20210628-18193523042
Electric Drone SubStations Missing Asset - Approver 2021

SUBSTATION FORM

Station: CRESTA PH
Head Quarter: Table Mountain
Date Inspected: Jun 28, 2021 11:58:00 AM PDT
Inspected By: [Redacted]

Asset Type: ETS.TXFR
Equipment: BANK 1 A PH
Is this a Re-Inspection Form?: No

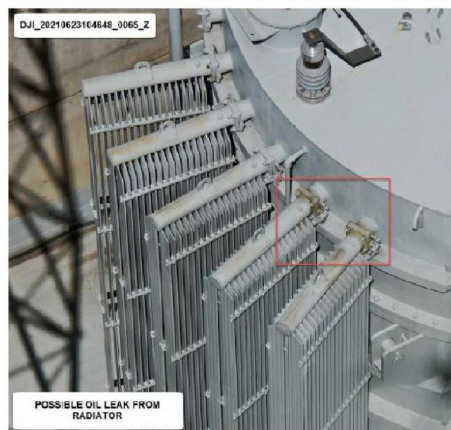
Any signs of leaks? Yes
Additional consideration may be required for this finding

↳ Describe Issue: ↳ POSSIBLE OIL LEAK

Please select all that apply Seeping

Problem Description	BK 1 A OIL LEAK
Facility/Equipment	Transformer/Regulator
Type	Power TXFR
Damage	Leaks
Action	Repair
Priority	B
Required End Date	2021-09-26
Identified in Field During	Station Inspection-DDSI
Clearance Required	Yes
Crew Class (Size)	SUB_ELE2
Est Hours	10
Est. Total Job Costs to Complete in Hrs (labor,materials,rentals, etc. - no travel time)	20
FIELD COMMENTS (Describe the work required and the equipment and the materials needed. For example: Special tools or equipment, any unusual conditions, special circumstances and supporting comments related to other information required)	BK 1 A OIL LEAKS
Select Tier	T3 Drone Inspection
ETS Type	ETS51 Repair & Return

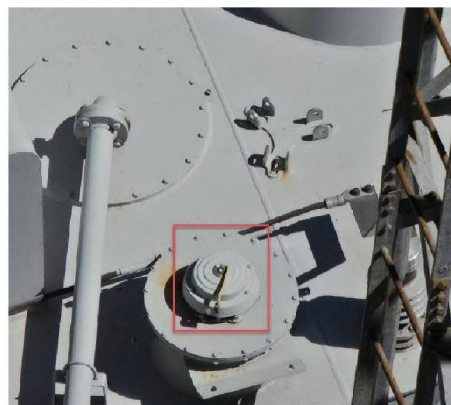
Is there indication of pressure relief device activation? No

↳ FLAG OUT OF ALIGNMENT

Is pressure relief device actuation flag damaged? Yes

↳ FLAG OUT OF ALIGNMENT

Non Conformances Flag Count (by Inspector)	3
SME Status	Approved
SME Notes	BK 1 A PRD FLAG OFFSET. OIL LEAK. HO IS GROUNDED NO ISSUES
A's	0
B's	2
E's	0
Non Conformances Flag Count (By SME)	2
Inspector Lan ID	[REDACTED]
Select SME (selected by Inspector)	[REDACTED]

Problem Description	BK 1 A PRD FLAG OFFSET
Facility/Equipment	Transformer/Regulator
Type	LTCR
Damage	Damaged
Action	Repair
Priority	B
Required End Date	2021-09-26
Identified in Field During	Station Inspection-DDSI
Clearance Required	Yes
Crew Class (Size)	SUB_ELE2
